SB, Riders, Steering column, 2003-04

Diagram no. 1

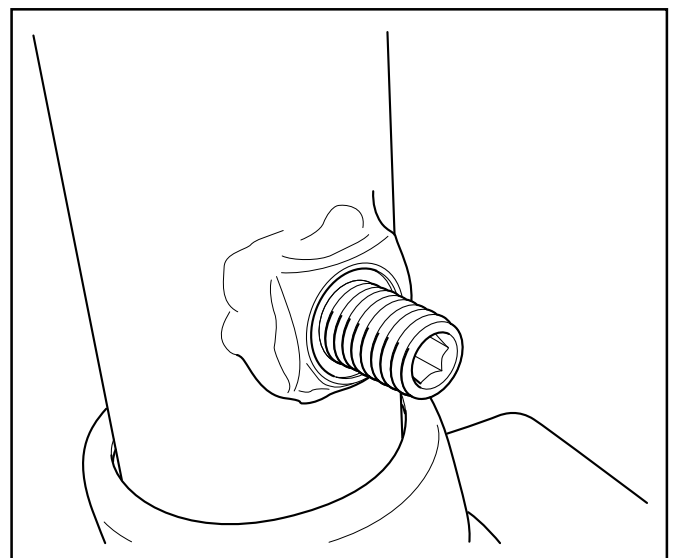
For a short period, steering columns have been produced with mounting holes that have too large a thread tolerance. See diagram no. 1.

This means that there is a risk that the threads on the mounting may be stripped if excessive torque is used when tightening the locking screws (728 74 55-05). See diagram no. 2.

If a thread is damaged it is recommended that an M8 Helicoil is fitted.
